**CITY OF CARLTON
PLANNING COMMISSION AGENDA
MONDAY, JANUARY 8, 2024, 6:00 P.M.
VIA ZOOM AND 945 WEST GRANT STREET**

A. Subdivision file #SUB 2023-02; 751 South 2nd Street – continued

To: Members of the Planning Commission
From: Scott Whyte, Contract Planner for the City of Carlton
Subject: Continued Public Hearing for 2nd Street Preliminary Subdivision, SUB 2023-02
Date: December 29, 2023, for the January 8, 2024, meeting

**CONCEPTUAL NEIGHBORHOOD CIRCULATION PLAN
 S 2ND STREET SUBDIVISION
 OPTION 2
 CARLTON, OREGON**

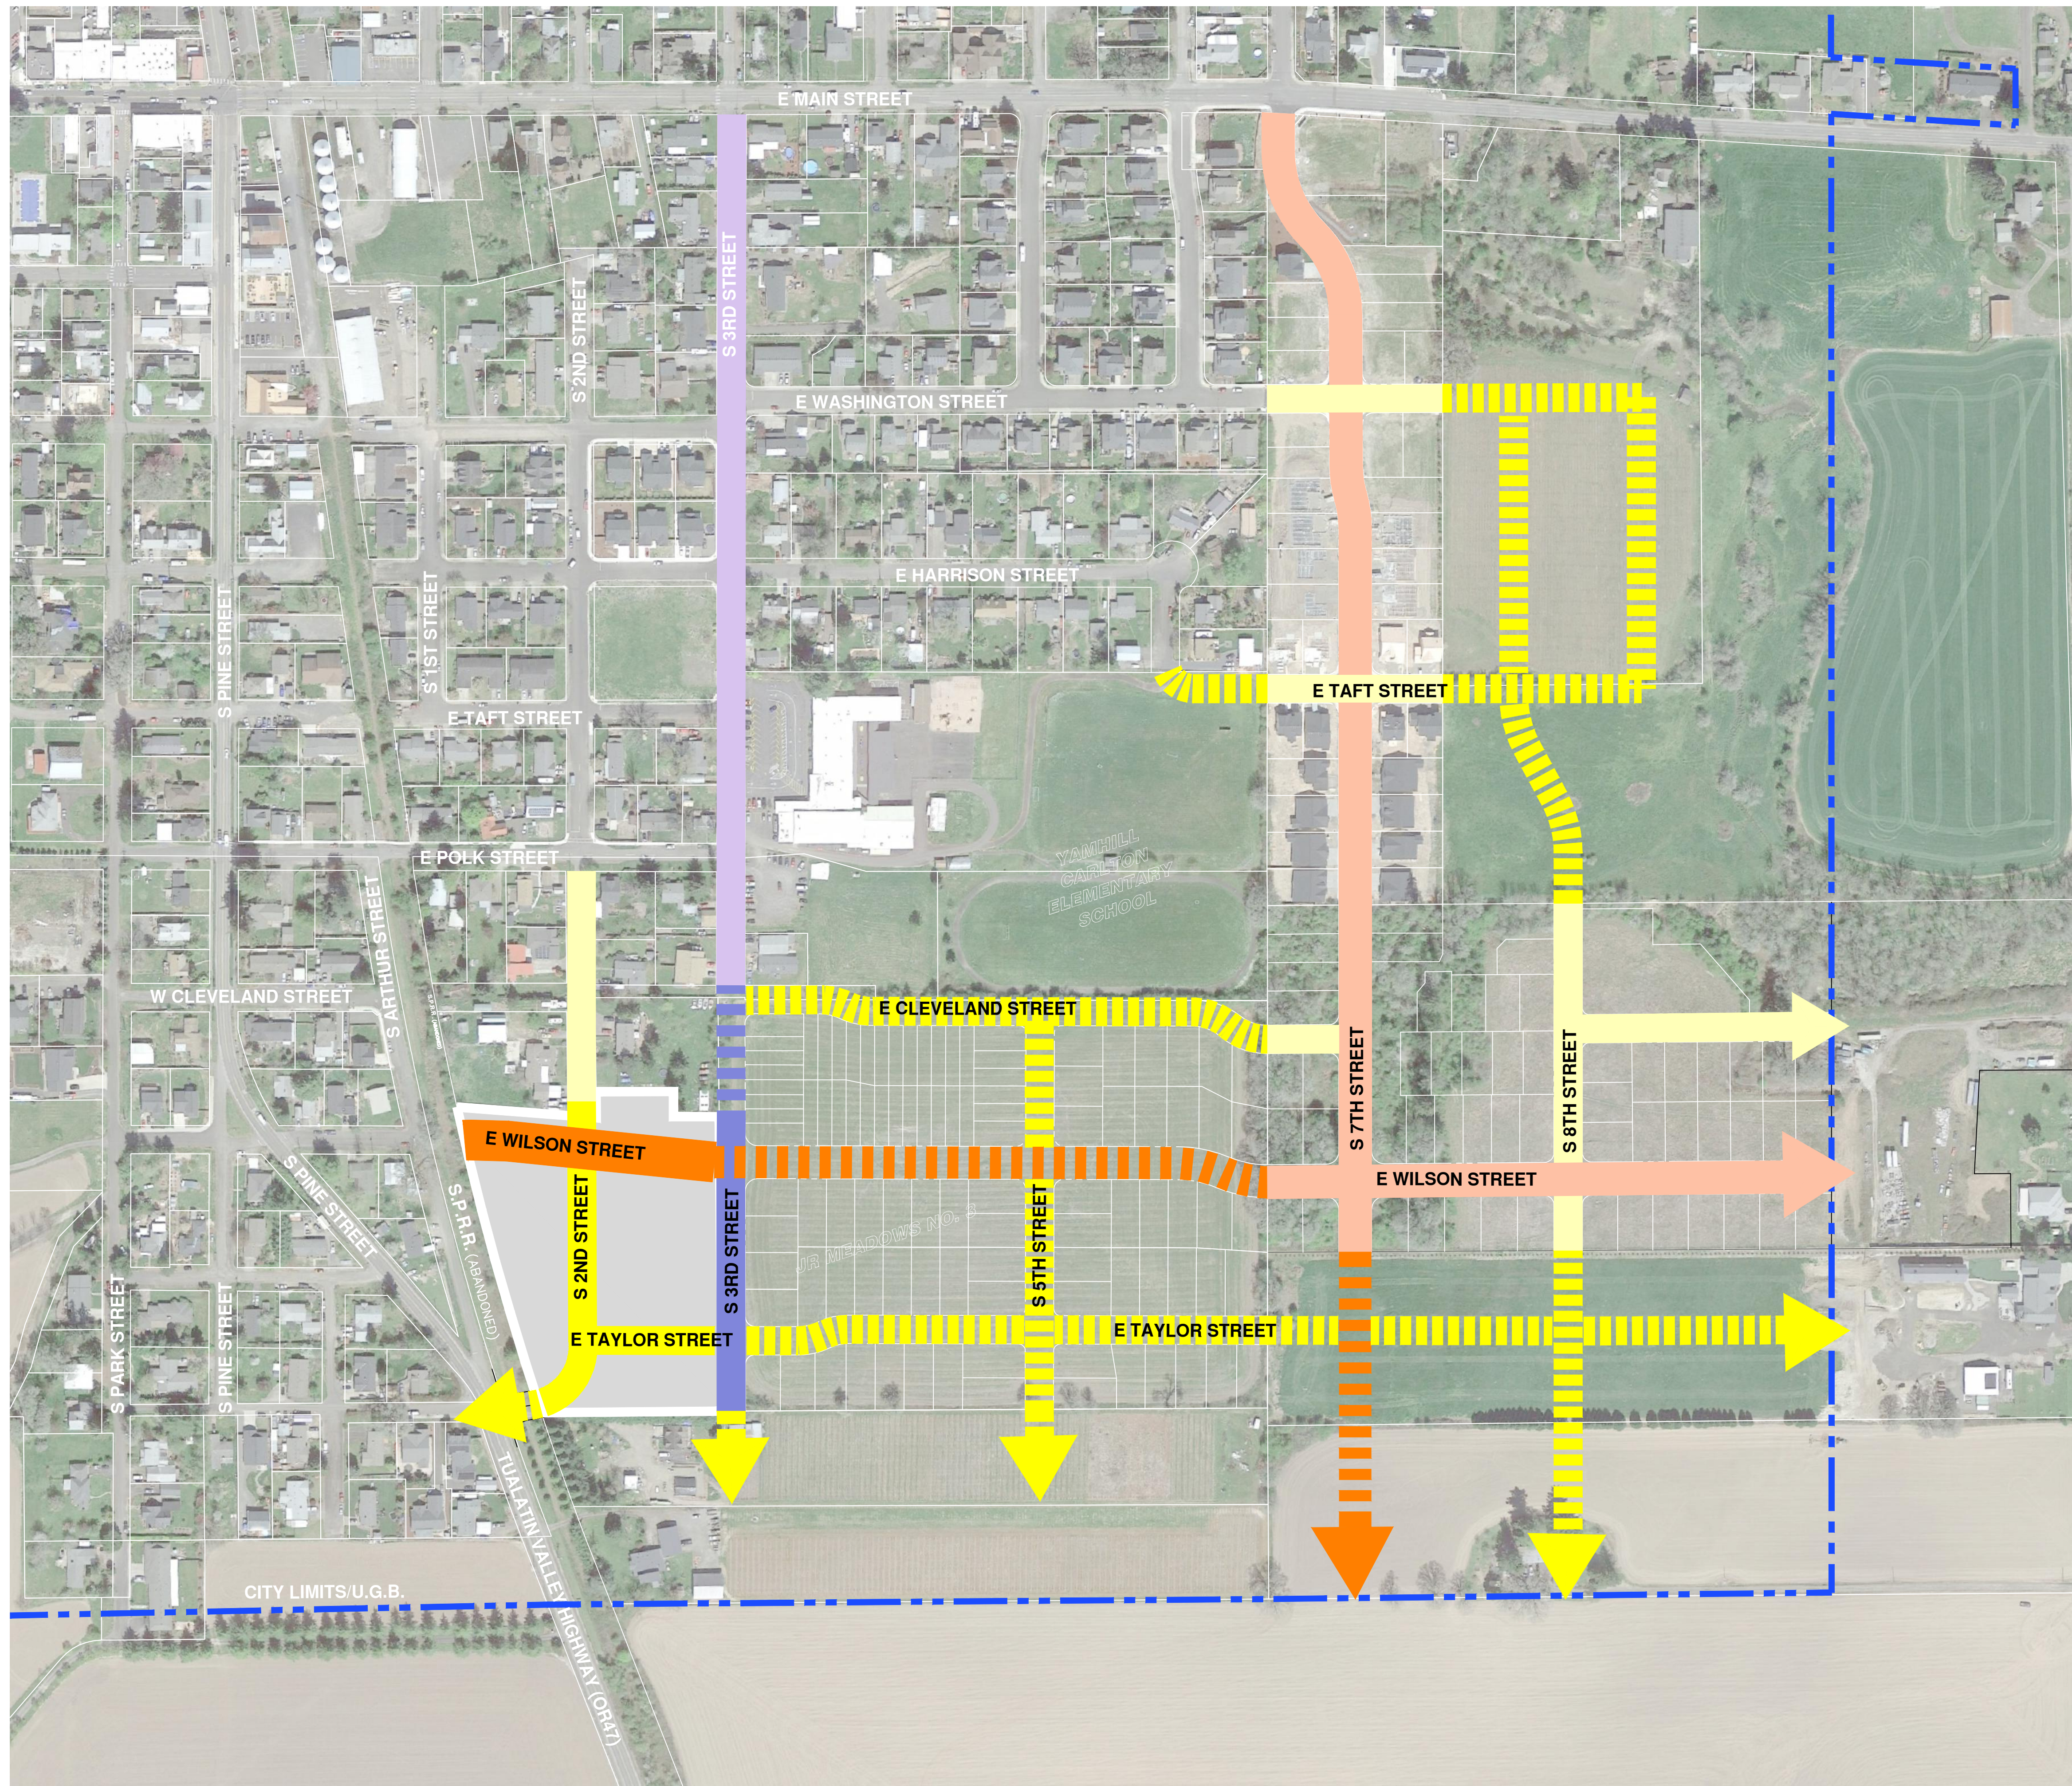
Supplemental Findings – Staff Review of **Exhibit B-8 - Alignment Option 2**: Exhibit B-8 is a full set of plans for Option 2 (J-turn connection). Plan details of Option 2 (e.g., number of lots, shape, % intended for detached / attached, etc.) were not available on November 13 for review. The full set submittal for Option 2 shows the same number of lots as Option 3 (39) together with the same number of lots intended for attached (14) and detached dwellings (25).

In review of the full plan submittal for Option 2, staff finds in support of applicable standards, including C and D Section 17.64.030 (shown to page two of this memorandum). Staff therefore recommends approval of Option 2 with conditions. Additional comments from the City Engineer are provided in this memorandum in review of the curvature / angle of 2nd Street in proximity to Highway 47 and the S.P.R.R right-of-way (addressed in response to the traffic memo herein).

**PRELIMINARY STREET PLAN
 S 2ND STREET SUBDIVISION
 OPTION 2
 CARLTON, OREGON**

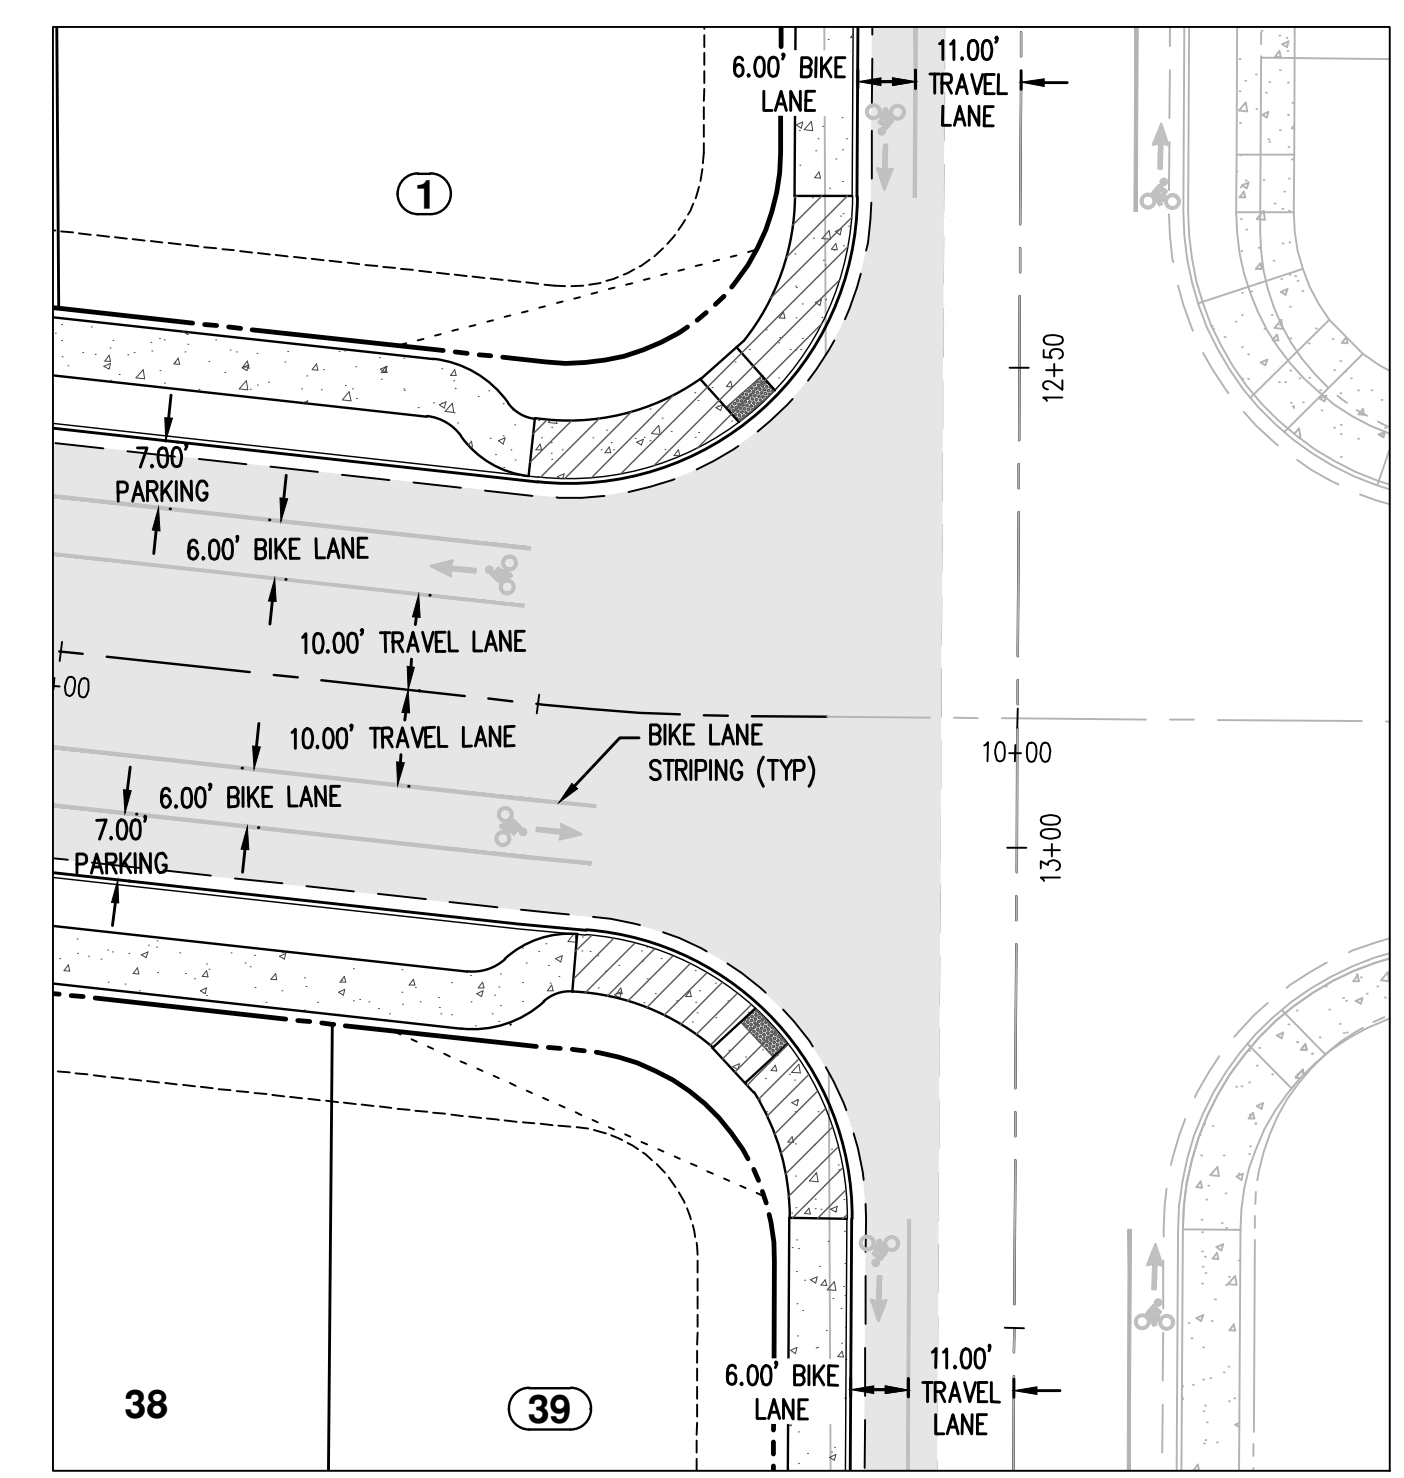
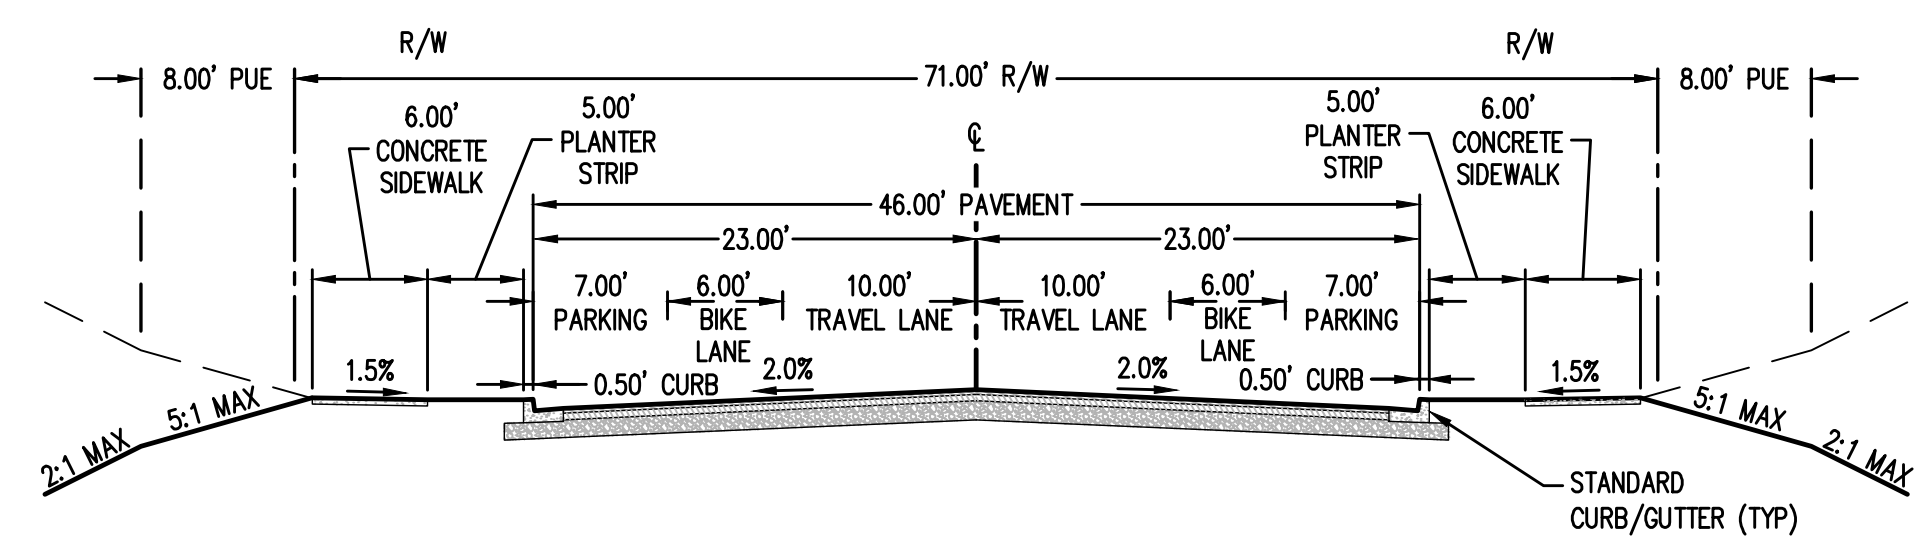
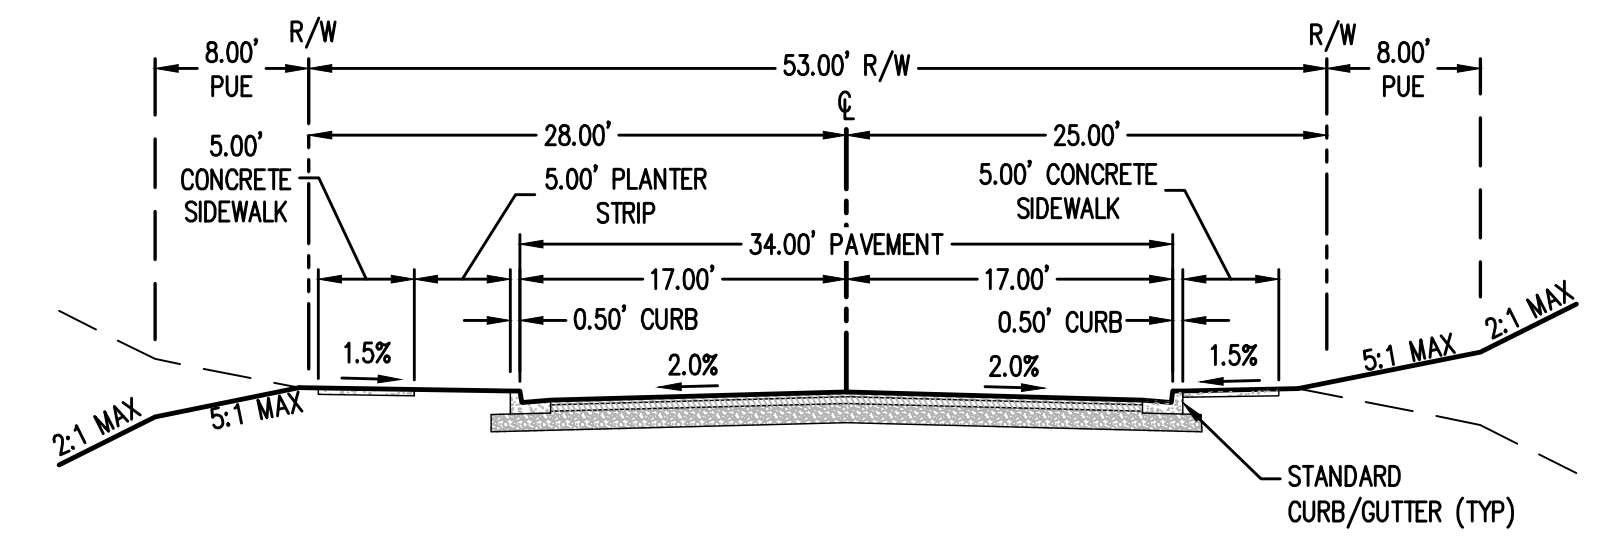
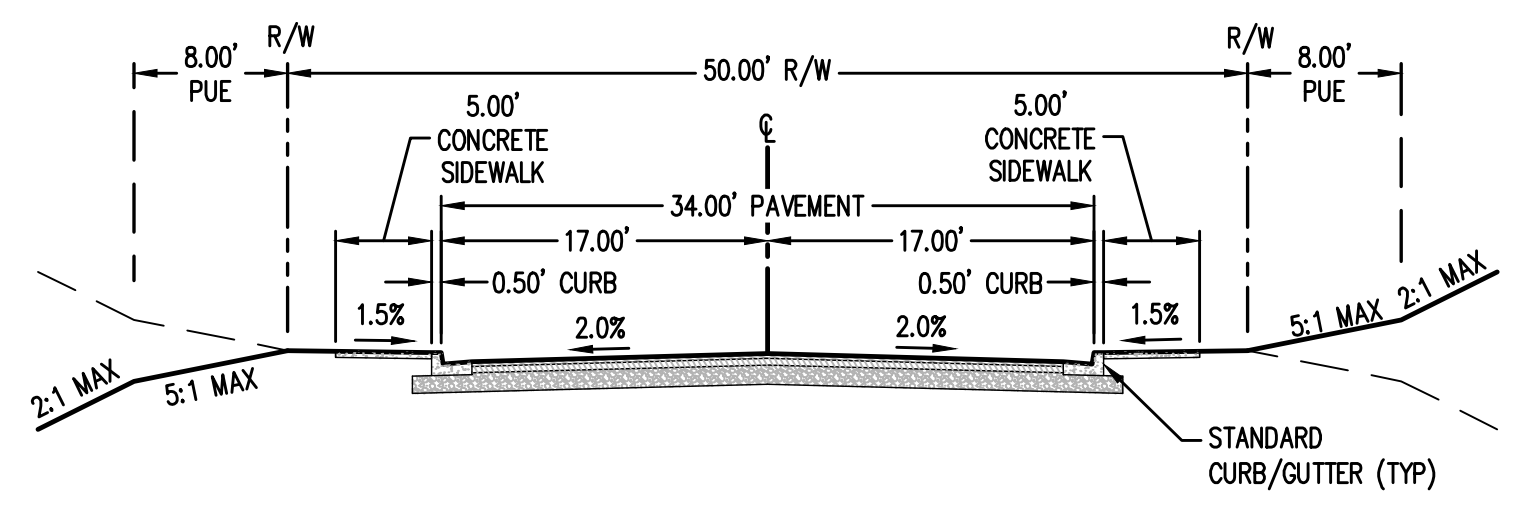
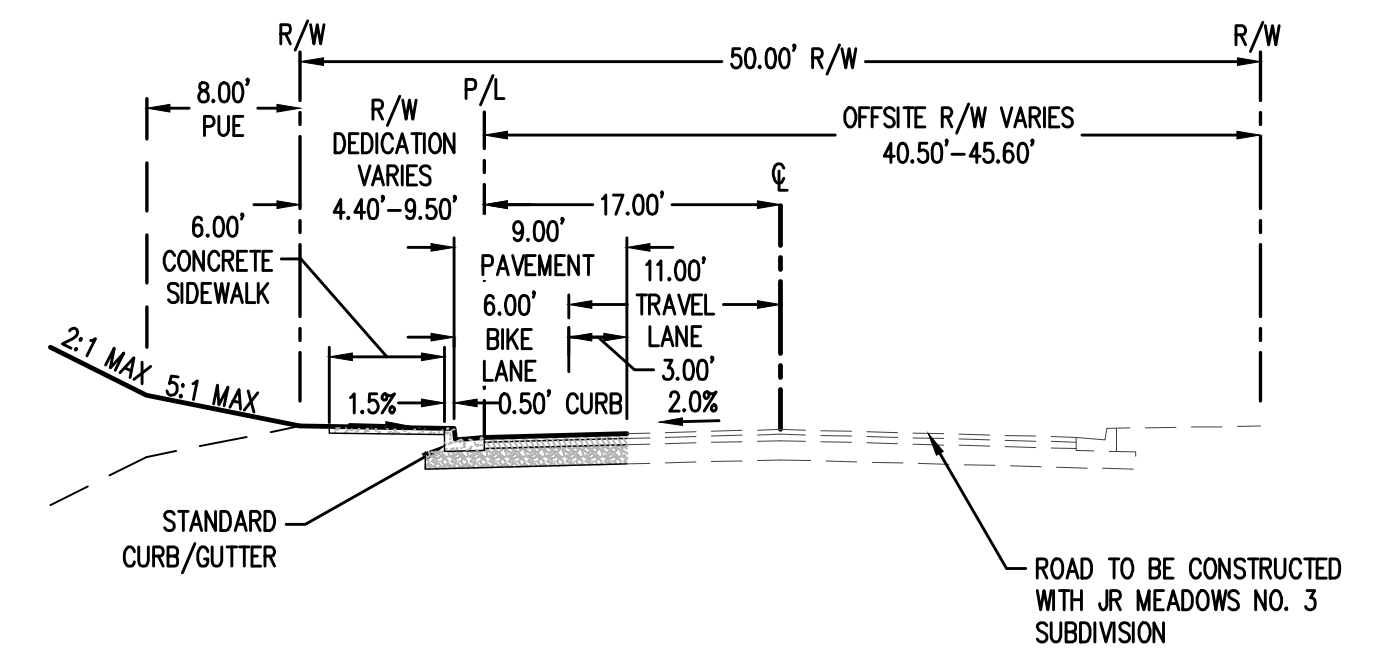
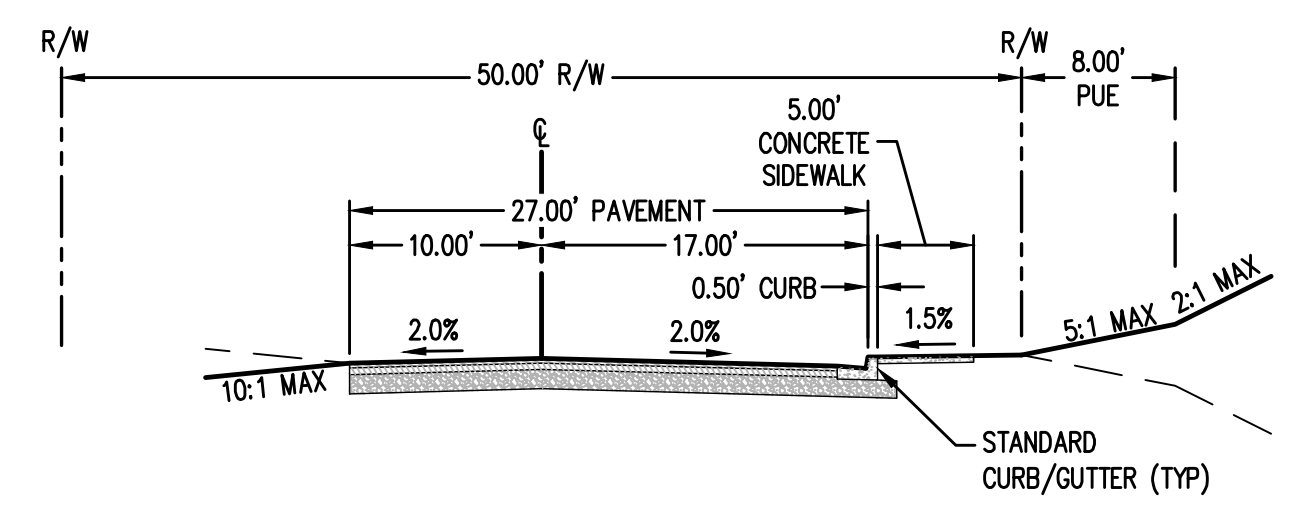
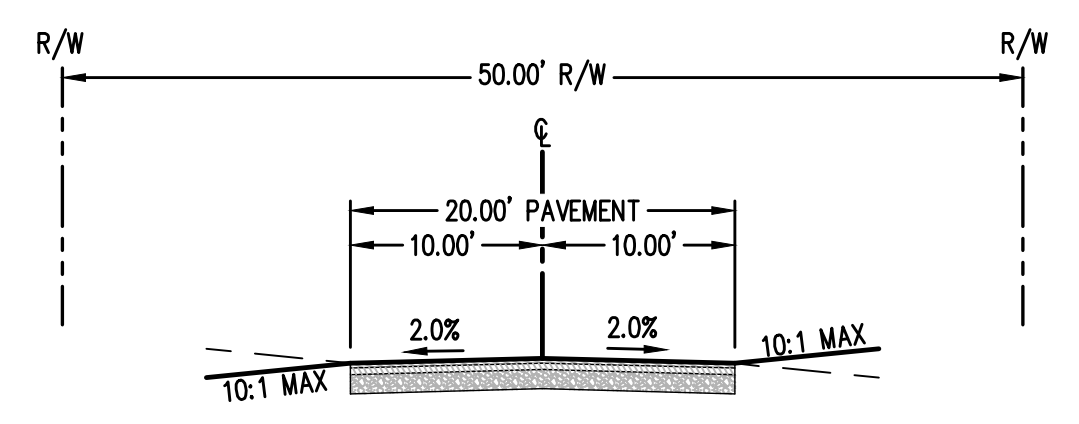
Staff Finding: The City Engineer observes the proposed curvature / angle of 2nd Street (in proximity to Hwy. 47 and S.P.R.R right-of-way) to be a very high level geometric depiction, and how the design standards can be met with refinements. In review of the full set of preliminary plans submitted for Option 2, the City Engineer observes the following to be addressed in construction design. These include:

- v. For Option 2, minor modifications are to be addressed in design including:
 - i. There is a 3' jog in the ROW at lot 19. The location of the jog may need to be adjusted based upon design issues for the sidewalk and ADA ramps.

The above modifications are included as part staff recommended conditions of approval (end of this report) if the Commission approves Option 2.
